## PROBLEM:

There have been complaints on early H1B motorcycles of sluggish performance in the low and middle rpm range.

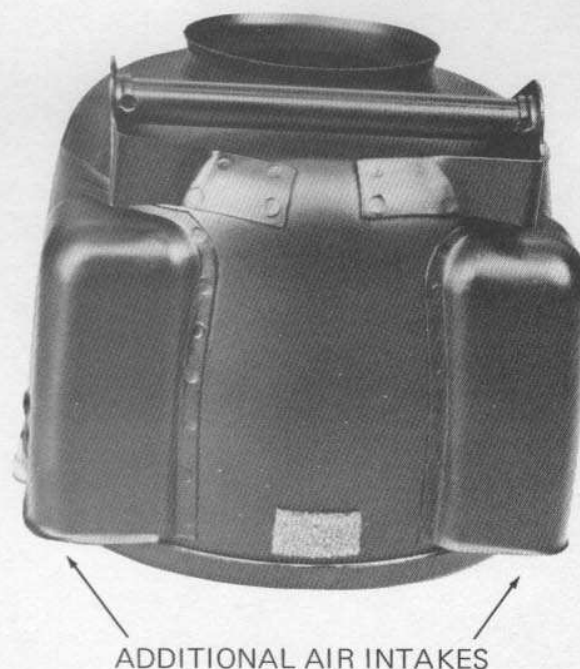
To improve the overall performance of the H1B, a new air cleaner was designed and a new set of carburetor specifications was used from mid-1972 production. This change is applied to all H1B's from engine number KAE-61607 and up.

The new air cleaner has two additional air intake ducts to increase the air intake capacity.
